**SITE INSTRUCTION**

SIN NO: **06**  
 CONTRACTOR: **Mr. Pat Newton**  
**Talco Building Innovations Inc.**  
 4728 Bank Street  
 Ottawa ON K1T 3W7

PROJECT NAME: **225 Huntmar**  
**Ottawa, Ontario**

PROJECT NO: 15-010  
 DATE: 2020, February 20

DATE	March 02, 2020	PROJECT NUMBER	15-010
SCALE	NTS	PROJECT NAME	Enterprise Rent A Car Kanata
			DESCRIPTION
			ROOF SECTION
			SK-11

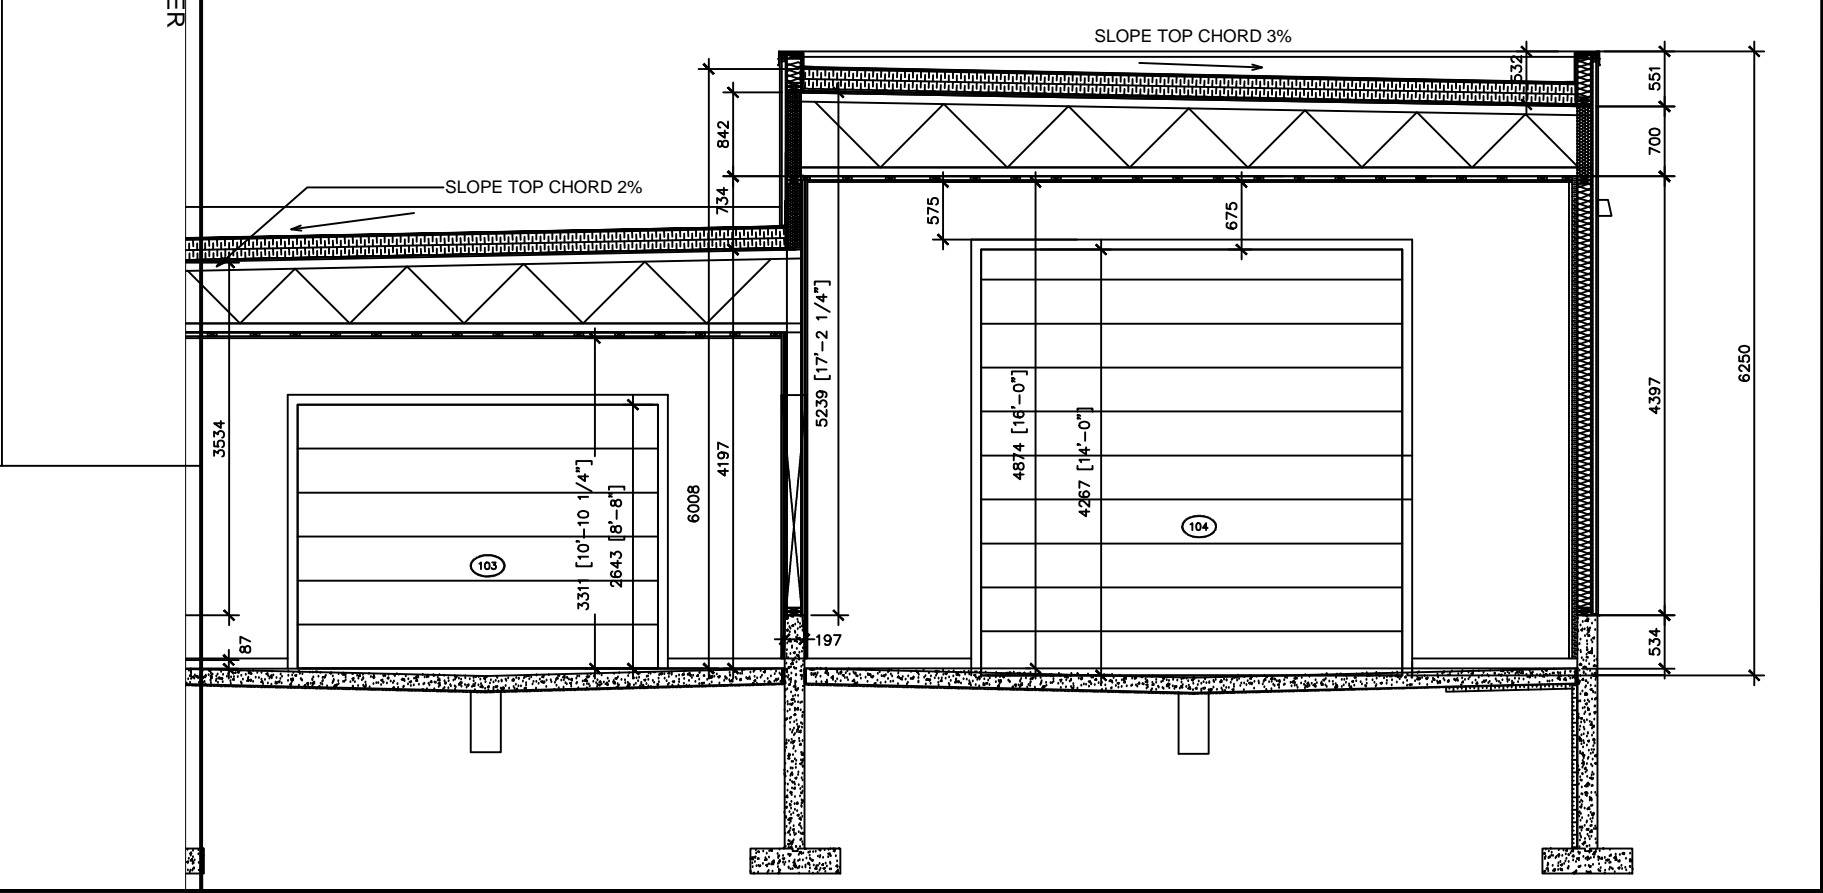
- Further to Contractor's Information Request #7, please see attached sketches SK-11, and SK-12.
  - revise required slope for truss top chord to 2%.
  - provided details indicating approximate maximum dimensions of truss profile to be determined by truss supplier.
  - provided truss bearing details, to be read in conjunction with the structural drawings issued for construction.
